Appendix C Agency Correspondence

Subject: Operational Improvements on SR-74 (EA 08690K)
(our file: Inter-jurisdictional Project Review 00-01, Ortega Highway Widening).

**Comments on the Notice of Preparation of a Draft Environmental Impact Report for Plans
to Widen State Route 74
Orange County
EA086900**

QUILITE® Noise Barriers

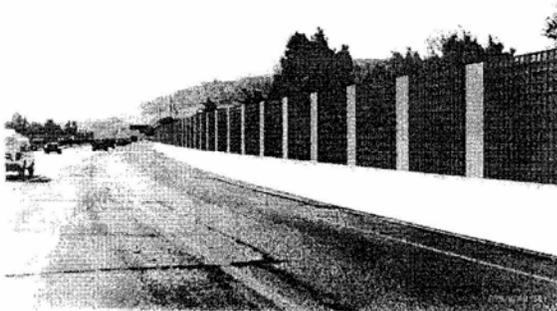
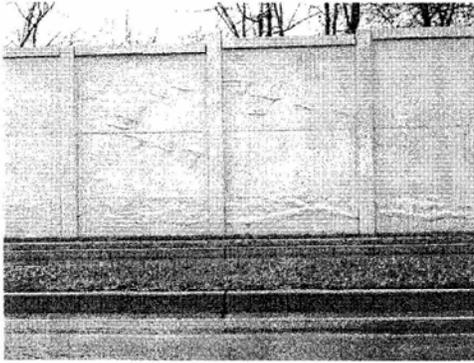
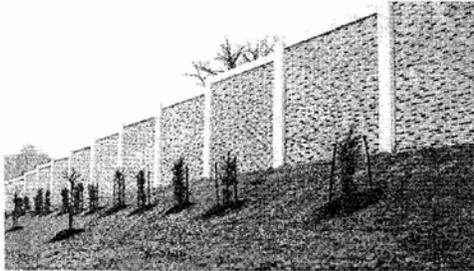
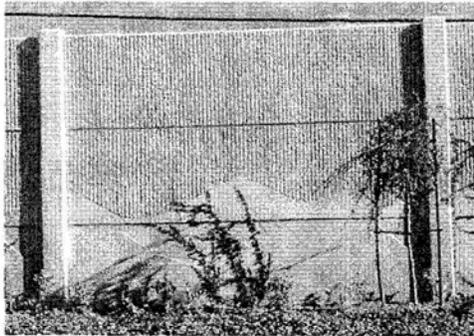
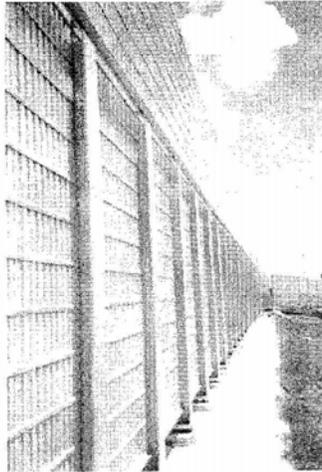
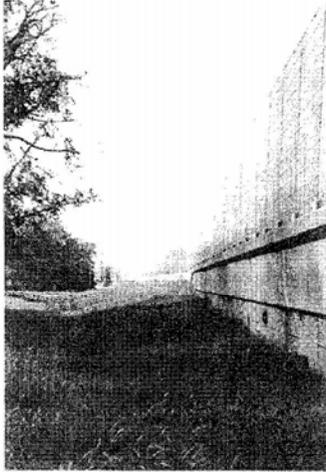
In response to your concerns in aesthetics and sound deflection, we have identified two sound absorbing wall systems for your consideration: QUILITE® Noise Barriers, and Sound Fighter® LSE Noise Barrier Wall System. These products are among the Department's current list of pre-qualified sound wall systems. The construction details for the specific project application need to be reviewed and approved by the Department's Office of Structure Design.

- 1) City needs to notify the Department in writing its selection of the sound wall type and aesthetic treatment by September 29, 2006.
